EAST ROCKVILLE DESIGN GUIDELINES  
Rockville, Md.

March 12, 2019  
**Draft for Discussion**

**DRAFT FOR DISCUSSION v2**

Roof Pitch (Issue 11)

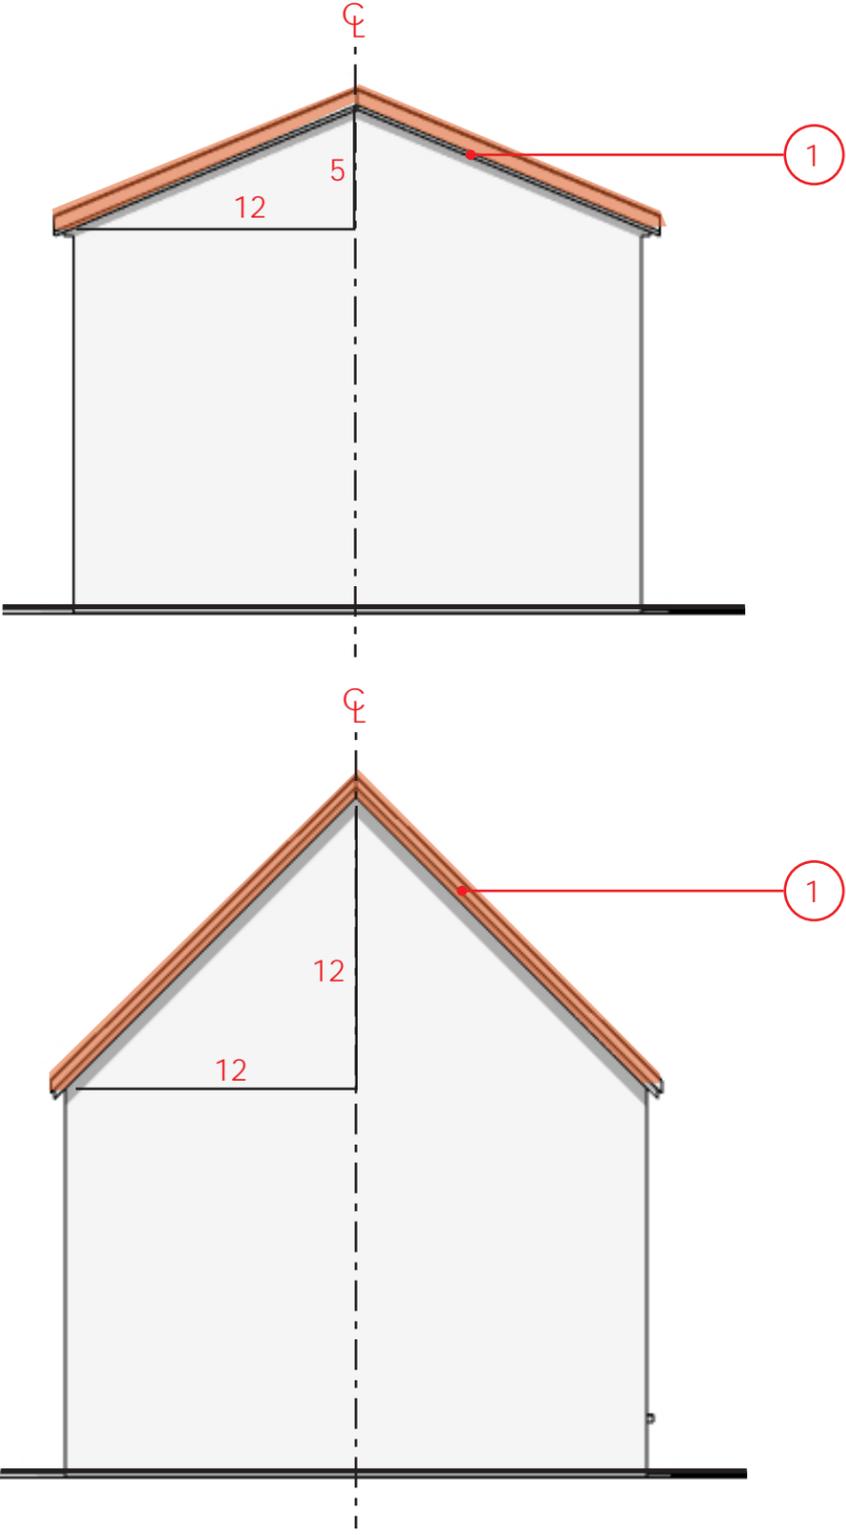
- 1) Does that prevent a dormer being added to one side (whose roof slope would not be symmetrical)? If so, I'd vote for making this "Should".
- Need flexibility to allow for other roof styles consistent with contemporary designs found in Montgomery County, MD. For example, 1950s "butterfly" roof designs or 1950s style flat roofs should be permitted. See page 44 of Montgomery Modern: Modern Architecture in Montgomery County, Maryland, 1930-1979 by Clare Lise Kelly, 2015.

- Change all shalls to should.
- 1) Do dormer windows need to be described here? what if a dormer window ends up being the side of (almost) the entire rear of building (i.e. raising the roof on the back? could we say that when raising the roof on the back, the original roof line shall stay visible?

- Add something along the lines of: Other roof lines that are appropriate to their architectural style and in keeping with the immediate couple of blocks may be permitted/approved by the director of planning.
